January 20, 2023

Re: AMC 11.50.035D.1.c. Design Advisory Board Member Minority Report Urging Reconsideration of 3-2 Vote To Adopt Revised Basis-of-Design Documents That Will Likely Increase Initial Port of Alaska Modernization Program Construction Costs by >\$200 million, and Future Costs By As Much As \$300 Million More, Without Adequate Justification

Image 2.0 100-gauge option with initial non-functional backreach area

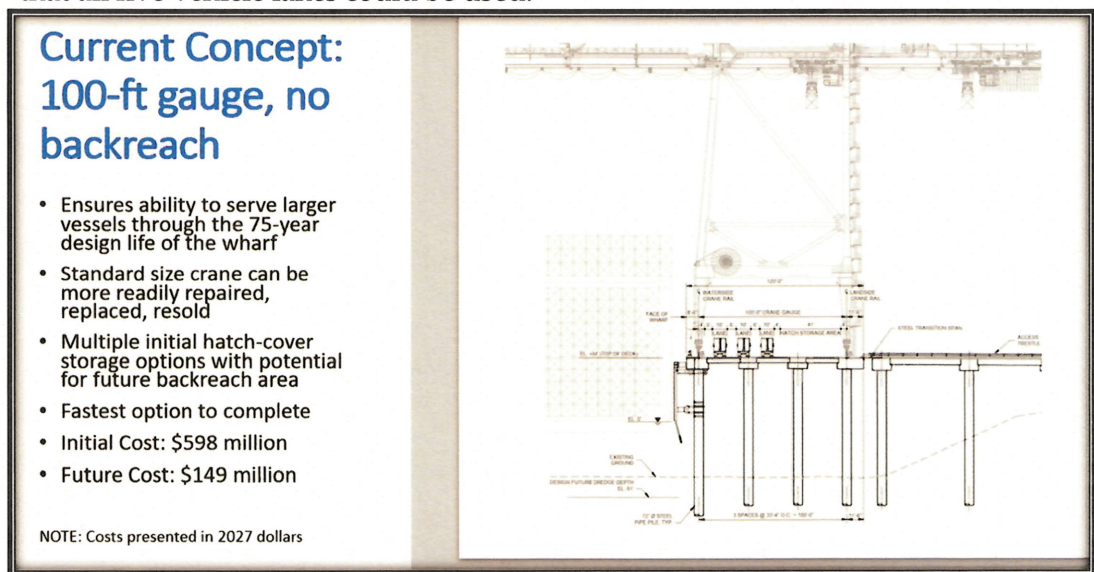
- (1) a 100-gauge crane accommodating option, which initially would have no “backreach area” for hatch covers; the option could result in five lanes of vehicle traffic, but two lanes would be sacrificed for hatch-cover storage; the initial cost of the option was projected to be \$598 million, but the costs would grow to \$149 million if the “backreach area” for hatch storage for was later made functional so that all five vehicle lanes could be used.

The remaining options, by contrast, all assumed that a “backreach” area would be built immediately; unsurprisingly, this resulted in significantly higher initial construction costs, even for docks accommodating smaller crane-gauges:

- (2) a 100-gauge crane option with a backreach area projected to cost \$731 million; Jacobs noted, however that “there’s not really a fiscal advantage to the city,” and “only a slight operational advantage [to users]” to actually construct the

“backreach area”; in Jacobs’s view, the “additional \$130 million investment” is not warranted in the short term;¹²

Again, we ask you to request the Design Advisory Board to reconsider its December 20, 2022 vote, and that you instruct Jacobs to present the Design Advisory Board with alternatives that:

- (1) do not involve the construction of three on-dock lanes for vehicle traffic
- (2) do not involve on-dock hatch-cover storage areas, and
- (3) do not needlessly require Anchorage’s two future cargo docks to be of equal width and/or to include crane rail facilities that will be immediately rendered unusable (i.e., filled in with concrete) to accommodate roll-on, roll-off activities.
